Project : Renos & Additions to Northern
Address: Lebanon Middle & High School

Change Order No: 8

To provide additional grading in order to keep the existing fiber ductbank in place per Steckbeck sketch/email dated 3-27-24. This cost will be offset by the credit offered by the EC. See the attached ECI PCO-05R dated May 22, 2024.

Infiltration Basin 2 Grading

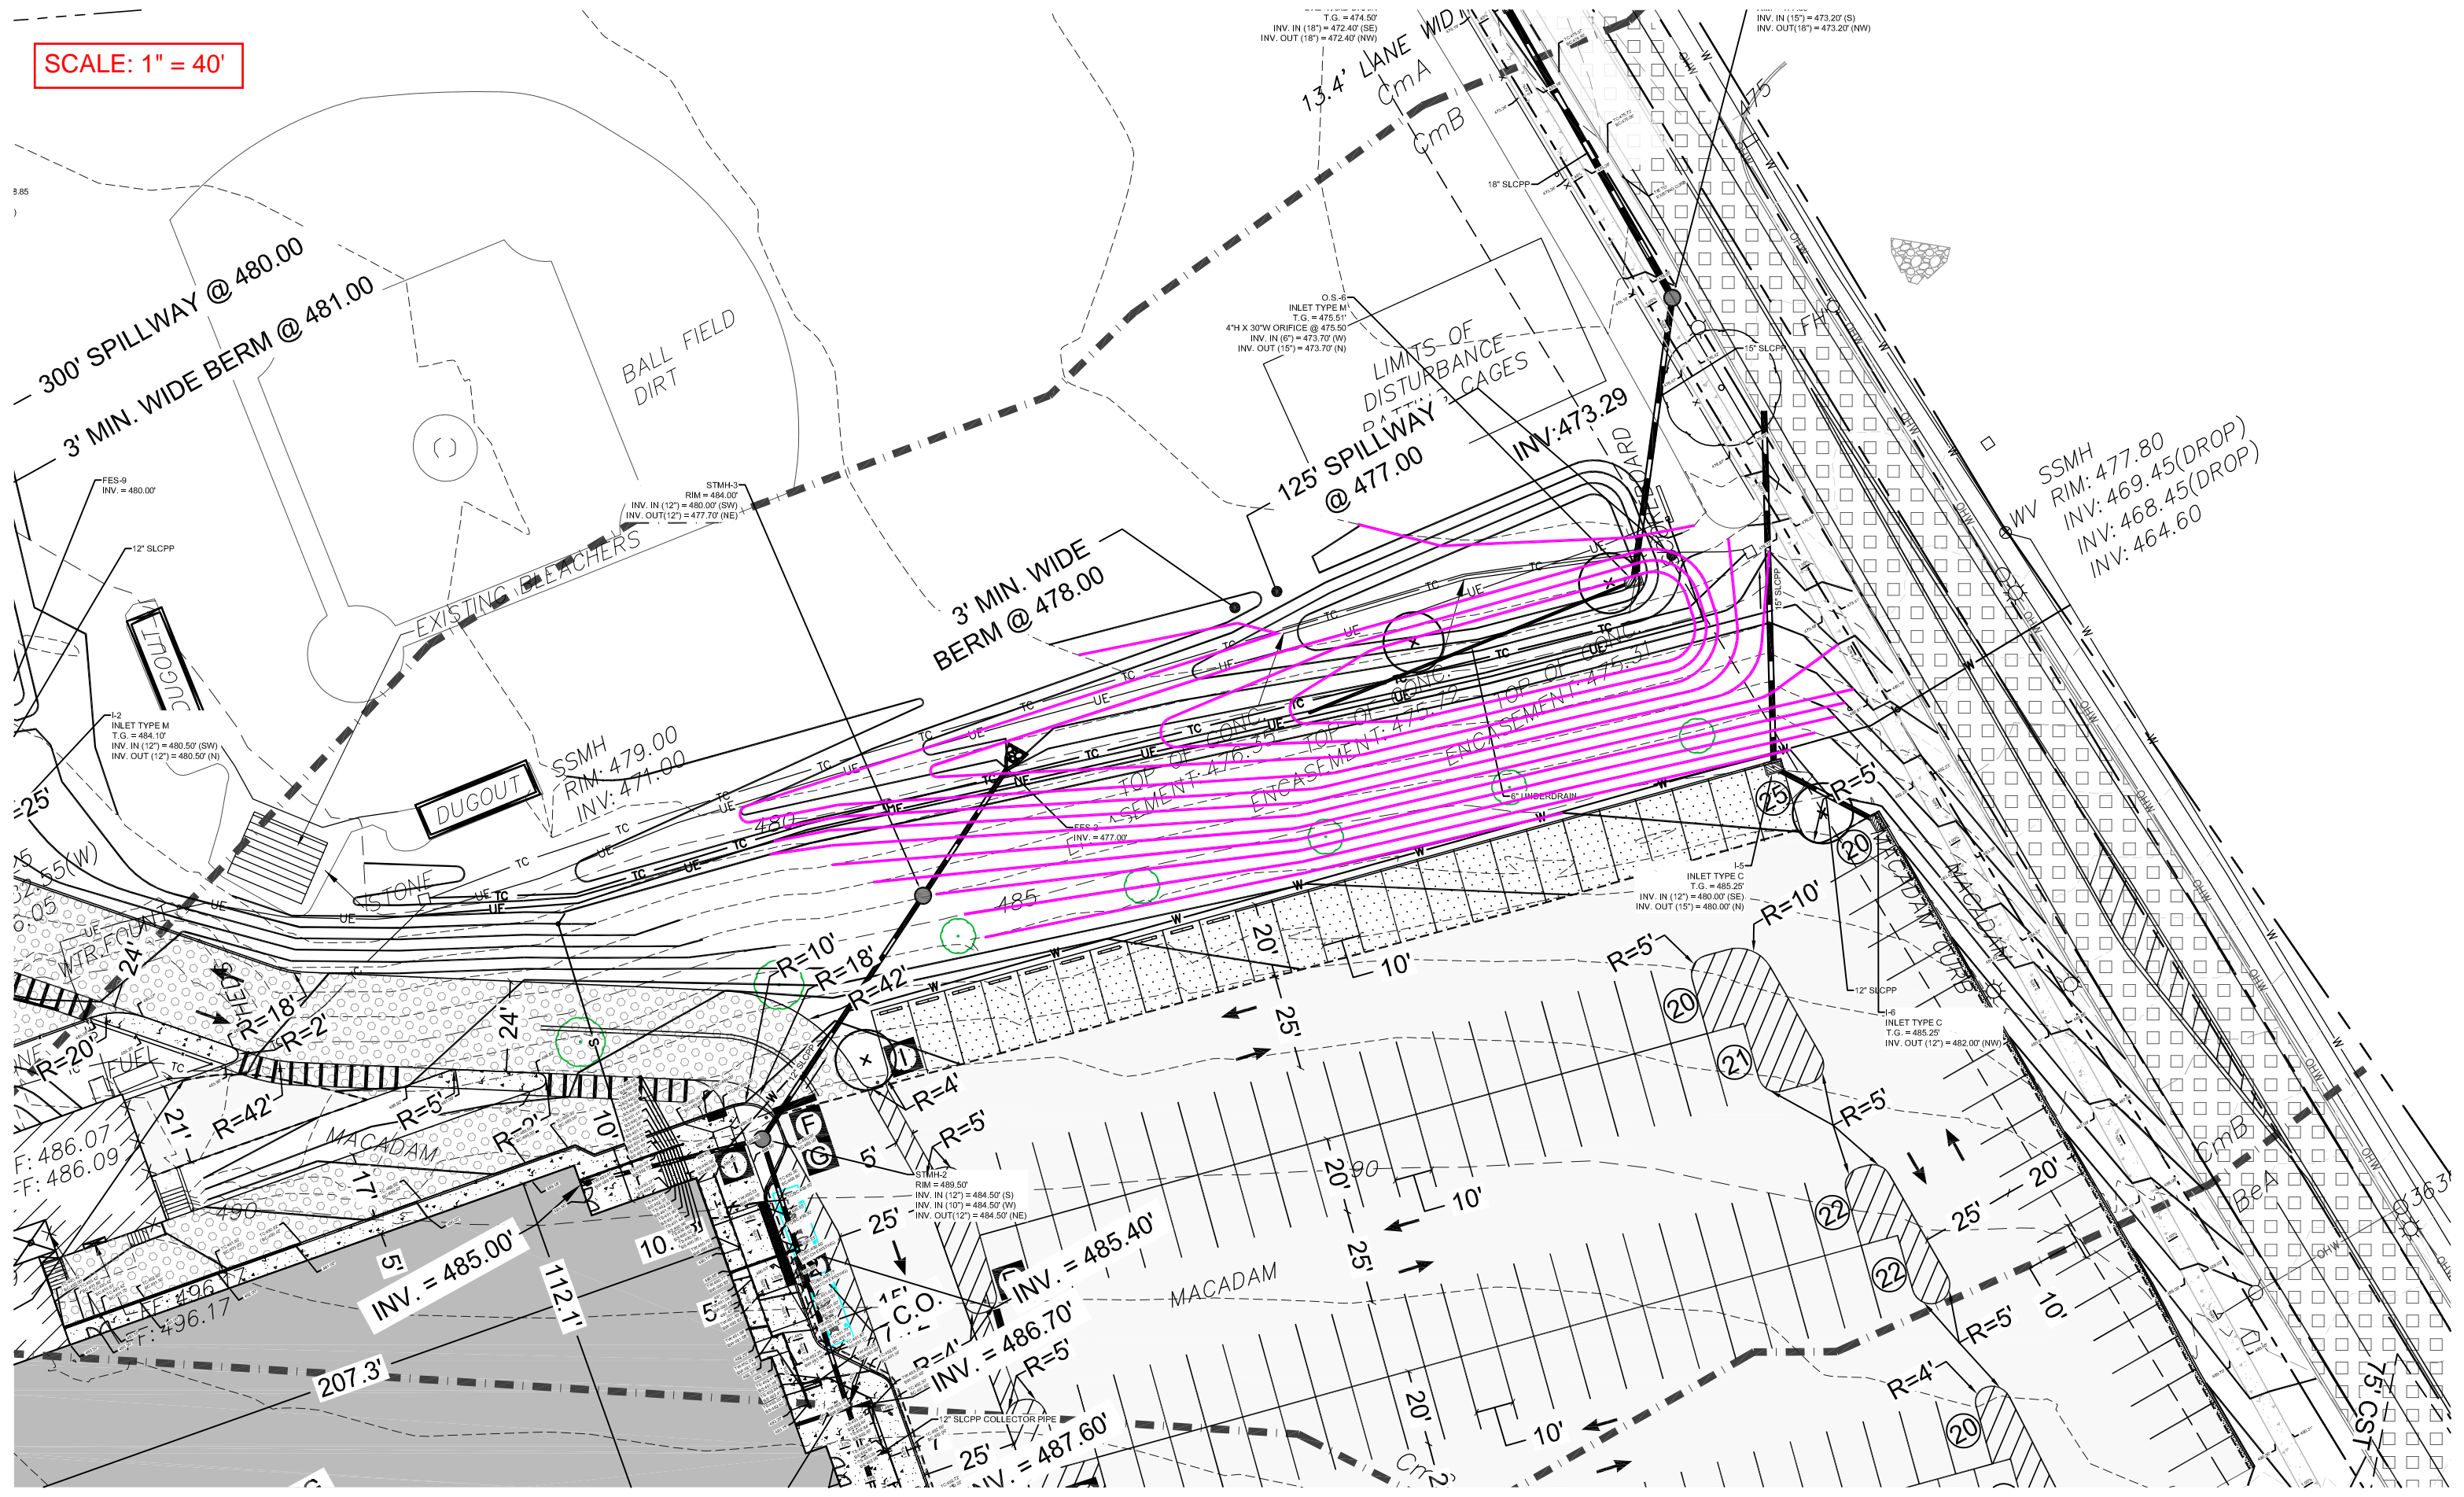
Good afternoon Dan – Please see below and attached for the sketch depicting the proposed location shift for Infiltration Basin 2, showing the basin bottom slid to the south by approximately 20 feet. I would expect to simply extend the outlet pipe to the new basin location, holding the same pipe inverts, which will lead to approximately 20 additional feet of pipe.

For this change, we may also need to add some erosion control matting for the 140' +/- of steep slopes that are generated by the basin shift.

To keep everyone in the loop on this, the duct bank happens to fall directly in the middle of our proposed basin bottom for Infiltration Basin 2. Our surveyed elevations show the top of the duct bank concrete encasement extending to elevation 475.50', which extends above our proposed basin bottom elevation of 475.00'. We are left with the following two options as it relates to the existing concrete encased TC duct bank:

1. We can attempt to re-grade the basin to push the basin bottom approximately 20 feet to the south, as depicted below in magenta grade lines. This would allow us to place the basin berm (Elev. 477.00+) over the existing TC facilities, thus avoiding the need for relocation. The issue here is that we will likely be required to prepare a revised PCSM submittal together for review by the Township Engineer, and perhaps also by the Lebanon Co Conservation District. I have an email out to the Township and LCCD to determine what we would be required to do in order to implement the grading change as depicted below. As an item of note, a large portion of the existing embankment slope to the north of the student parking lot would need to be re-graded in order to avoid the relocation of the existing duct bank. From what I understand, this existing gradual slope is currently used for

seating during baseball games. We would be able to leave some of the gradual slope in-place, but we would need to transition to a :1 slope for an approximately 150-ft section of the embankment.

Scope of Work: Provide revised grading per sketches in 3-27-24 email from Steckbeck including export of additional material and stabilization.
